ADDENDUM TO THE SECOND FIVE-YEAR REVIEW REPORT

**For the
Ralston Site
Cedar Rapids, Linn County, Iowa**

December 2013

RE: Second Five-Year Review
Former Ralston Disposal Site
Cedar Rapids, Iowa
EPA ID No. IAD980632491

FIGURE	1	REVISION	
FILE NAME

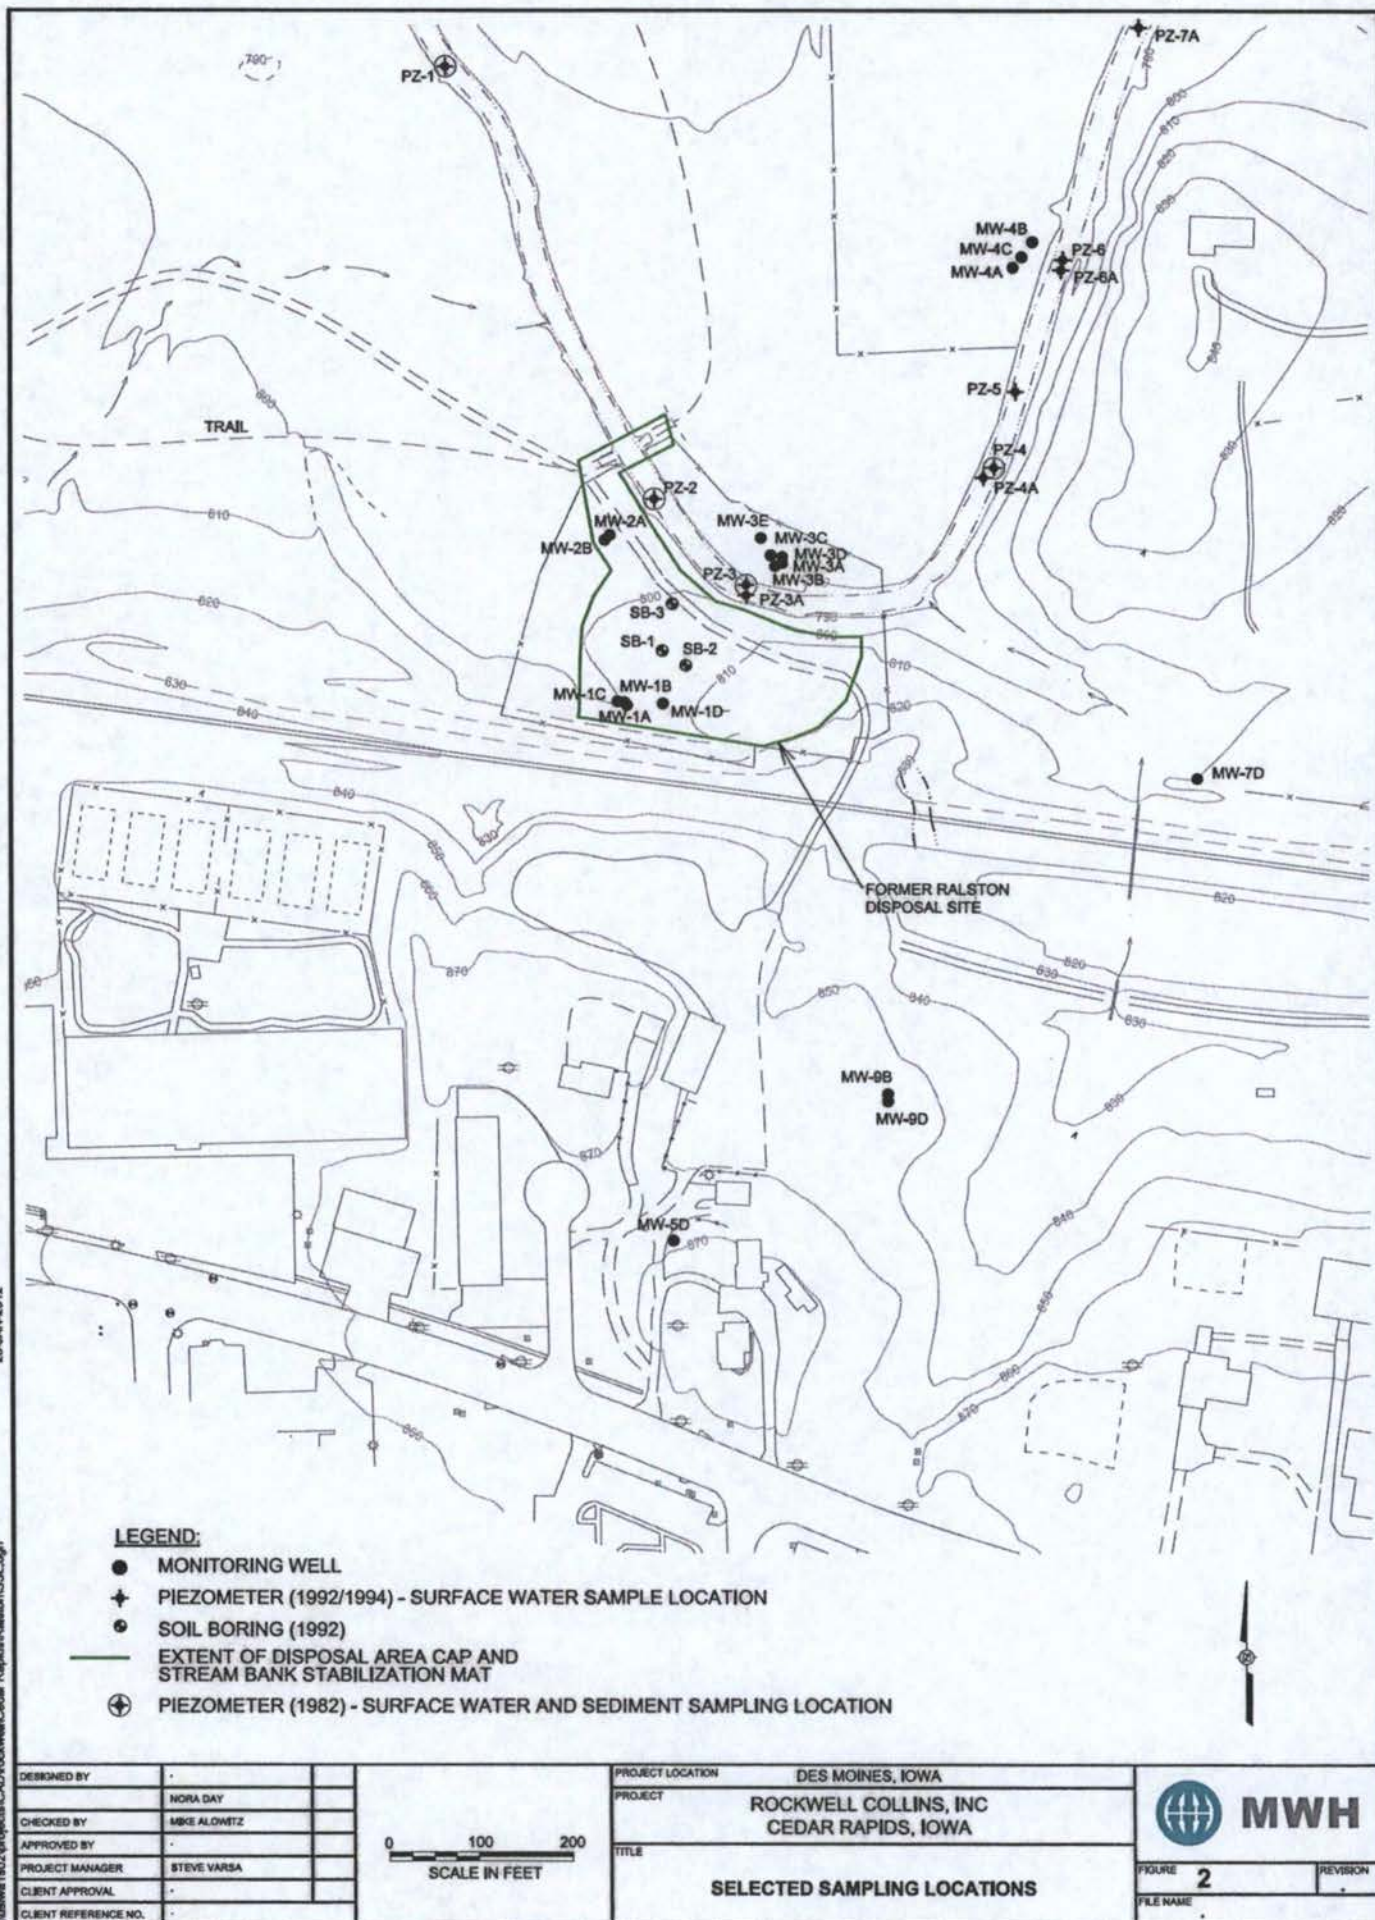
- 1) *It is not clearly demonstrated that the extent of contamination has been defined to the east of MW-3B or MW-9B in the Devonian aquifer.*

To evaluate the variation, the groundwater flow direction in the B-series wells monitoring the Devonian bedrock aquifer during the RI and subsequent groundwater gauging events, was compiled. A summary of the gauging data from the B-series monitoring wells is presented in Table 1. Table 1 also includes monitoring well gauging and groundwater elevation data collected in 2011, as part of the planned annual site monitoring activities. The locations of the B-series monitoring wells and other features in the vicinity of the Site are presented in Figure 1. Historical groundwater flow directions were evaluated in monitoring wells MW-1B, MW-3B, and MW-9B; and monitoring wells MW-2B, MW-4B, and MW-9B using gauging data collected since September 1994, following the installation of MW-9B. These two data sets were selected as groundwater between them passes through the Site, as depicted in Figure 1.

MWH, therefore, concludes further delineation of the groundwater plume in the Devonian bedrock aquifer is not warranted.

GRAPH A-1: Groundwater Flow Direction and Gradient - MW-1, MW-3, and MW-9

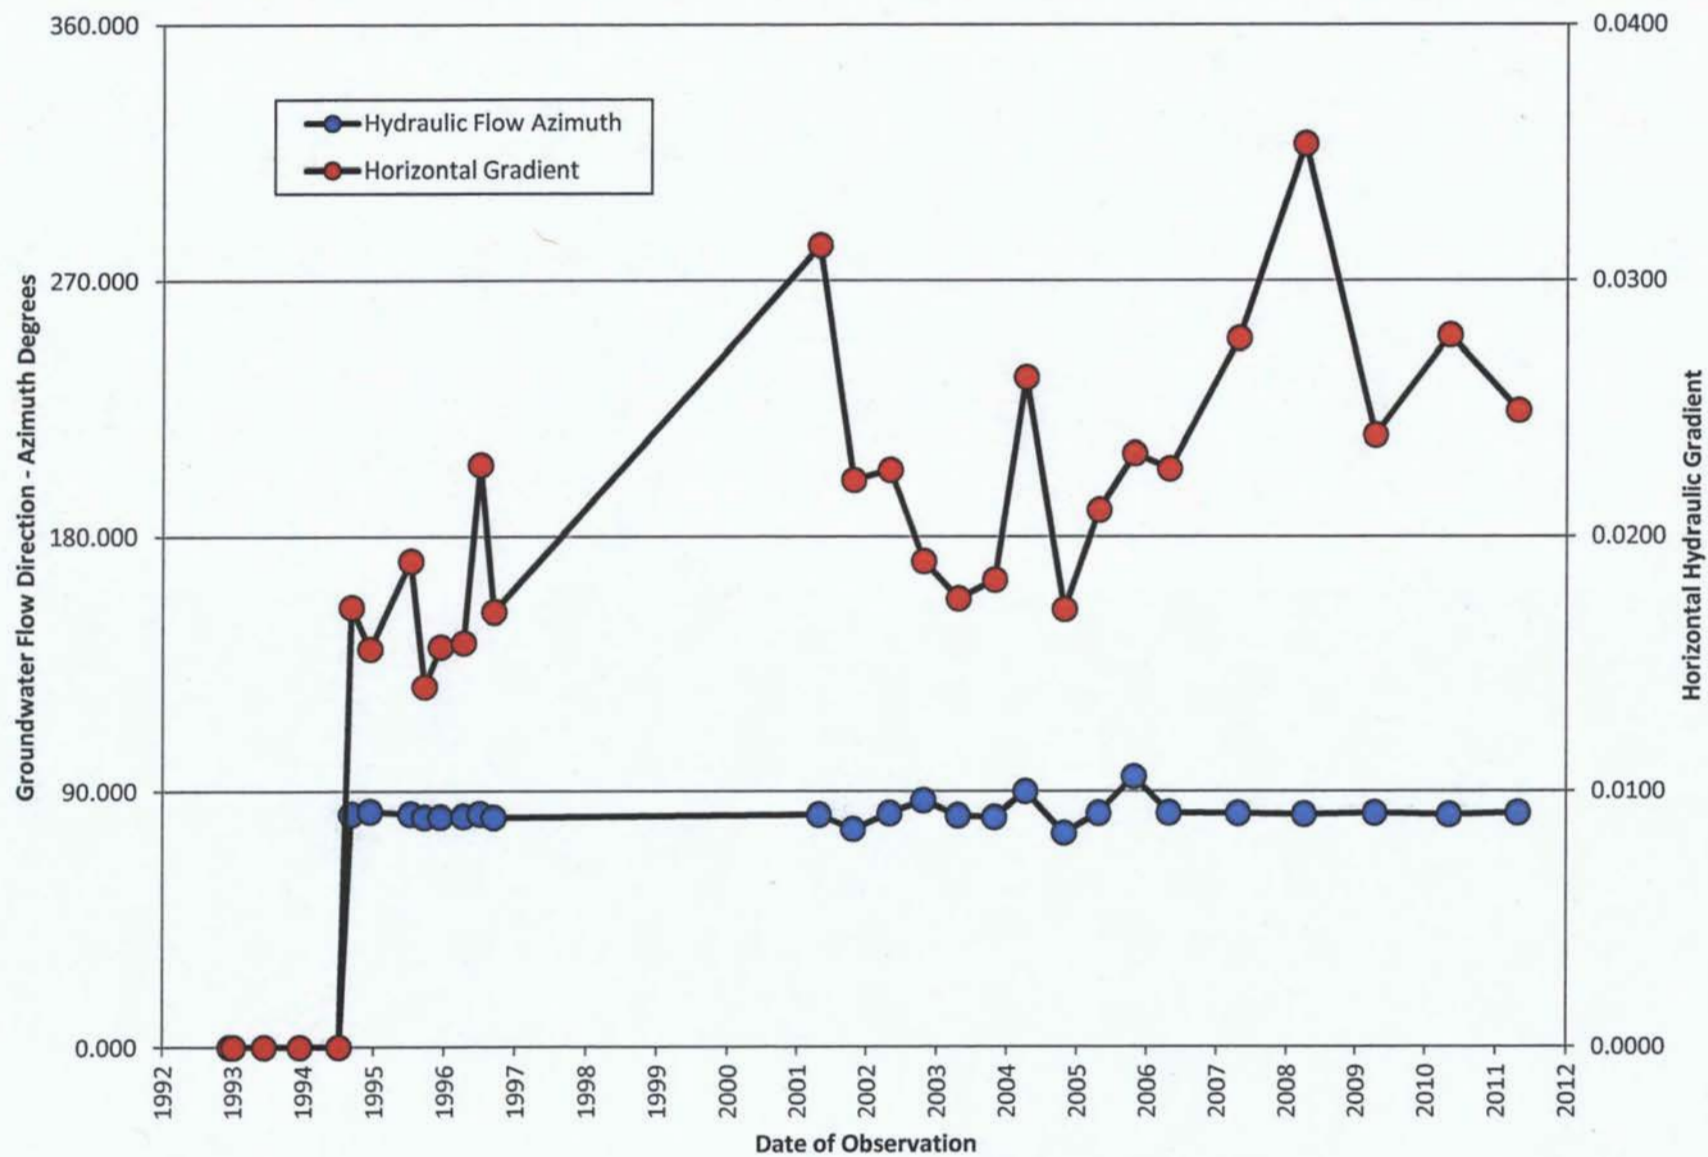
The groundwater flow azimuth calculations were graphed to show the changes in groundwater flow direction and hydraulic gradient as a function of time. Graphs depicting the calculated groundwater flow azimuth for monitoring wells MW-1B, MW-3B and MW-9B, and MW-2B, MW-4B, and MW-9B, respectively are included in Attachment A. As depicted in Graph A-1, the groundwater flow azimuth was calculated to approximately 82 degrees, ± 1 degree, or easterly direction over the past five years. This azimuth range mirrors the azimuth range calculated for these monitoring wells using data collected from 1994 through 1996, which was included in the RI. Variation in groundwater flow azimuth of 75 degrees (October 2001 and October 2004) to 95 degrees (October 2002, April 2004, and October 2005) was noted in several of the gauging events completed between 2001 and 2005. The cause of the variability during this period is not clearly evident, but generally coincides with a period when groundwater elevations were generally lower than the past five years.

Based on these calculations, a significant shift in groundwater azimuth is not evident at the Site based on the groundwater gauging data, and installation of additional groundwater monitoring points to assess the Devonian bedrock aquifer is not proposed. The extent of groundwater impacts of trichloroethene (TCE) and cis-1,2-dichloroethene (cis-1,2-DCE) east of MW-3B has been delineated in the Devonian bedrock aquifer during the advancement of monitoring well MW-7D, where analysis of groundwater collected through packer sampling was completed at a depth of approximately 63 to 68 feet below ground surface (bgs), as presented in Table 5-3 of the RI.

GRAPH A-2: Groundwater Flow Direction and Gradient - MW-2, MW-4, and MW-9

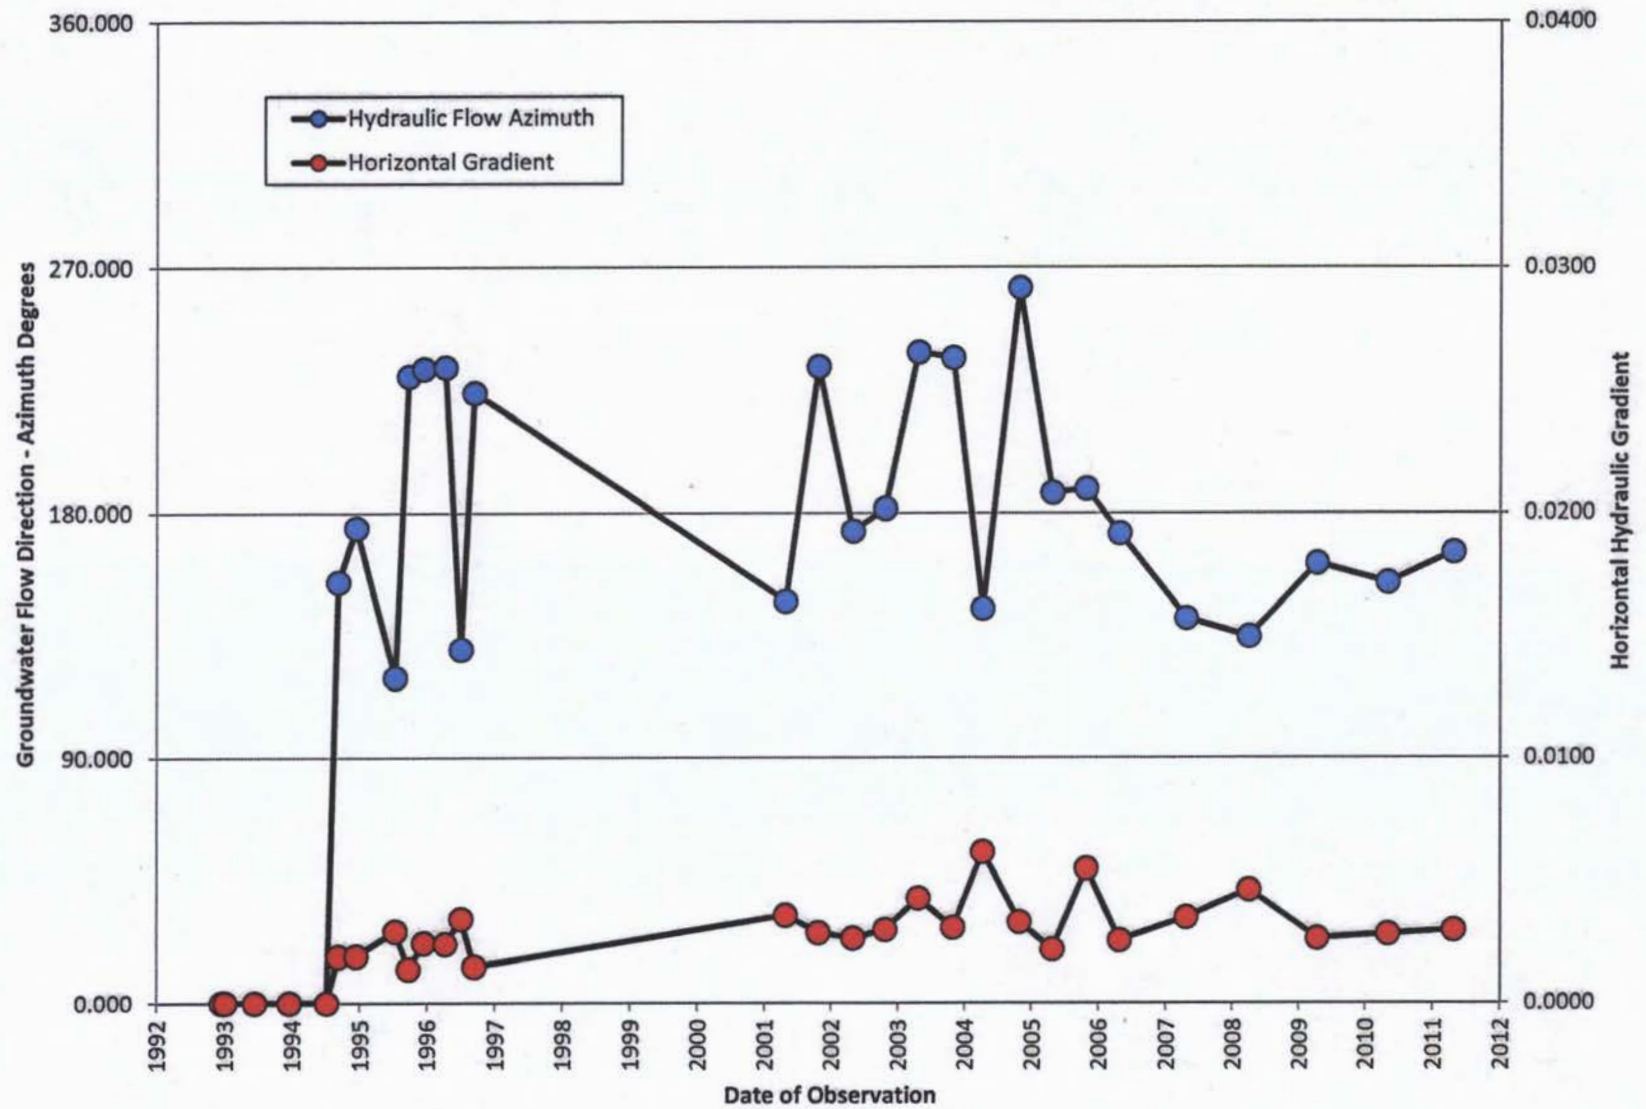
As depicted in Graph A-2, the groundwater flow azimuth for monitoring well gauging data collected from MW-2B, MW-4B, and MW-9B varied from 119 degrees (southeast) to

262 degrees (west) during the gauging record. Beginning in 2005, the groundwater flow azimuth calculated for these three monitoring wells has been consistently to the south and southeast, but within the azimuth range calculated with the data collected during the RI.

FIGURE 1

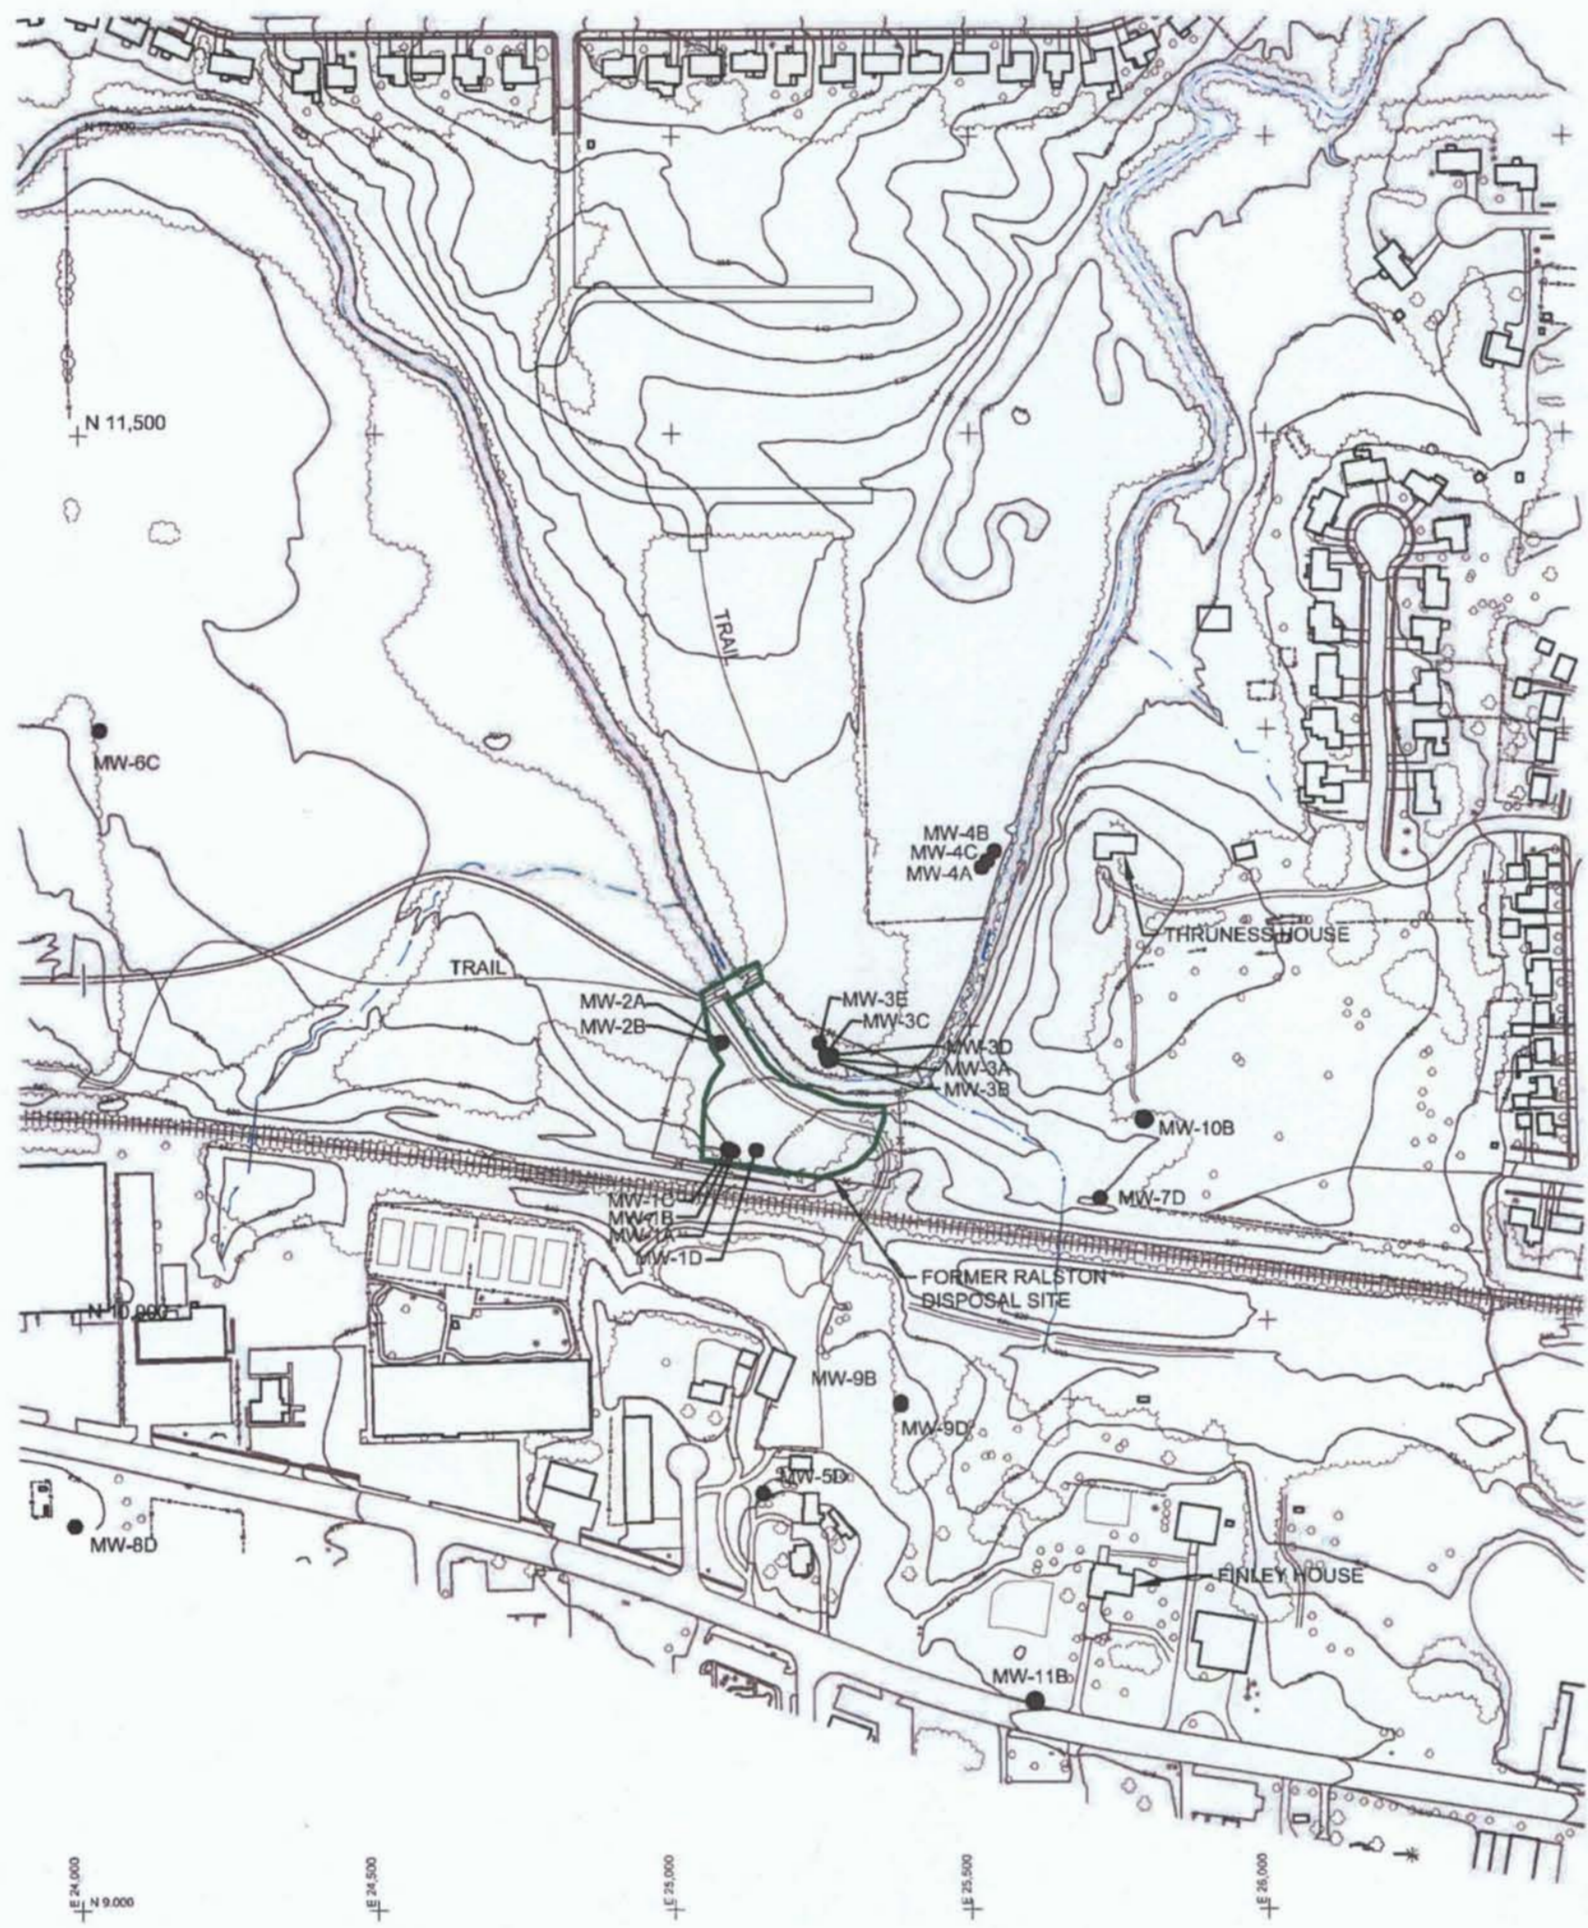
Two monitoring wells, MW-10B and MW-11B, were installed at the Site between May 14 and 21, 2013. The purpose of the installation of MW-10B and MW-11B was to create groundwater monitoring and sampling points to delineate the extent of groundwater impacts in the Devonian aquifer east of MW-3B and southeast of MW-9, respectively. Monitoring well MW-10B was also located to delineate groundwater impacts in the Devonian aquifer between the Site and the Thurness residence, which would provide information necessary for a vapor intrusion evaluation. (Issue 2) The location of these monitoring wells is shown in Figure 1, attached.

These new monitoring wells, as well as others associated with the Site, were gauged to determine the direction of groundwater flow. It was determined that groundwater flow in the Devonian aquifer was to the east and southeast, as depicted in Figure 2. MW-10B and MW-11B, as well as the other monitoring wells that comprise the monitoring network for the Site, were sampled for volatile organic compounds (VOCs). As summarized in Table 1, VOCs were not detected in MW-10B or MW-11B above a detection limit. The extent of groundwater contamination has been defined to the east of MW-3B or MW-9B in the Devonian aquifer.
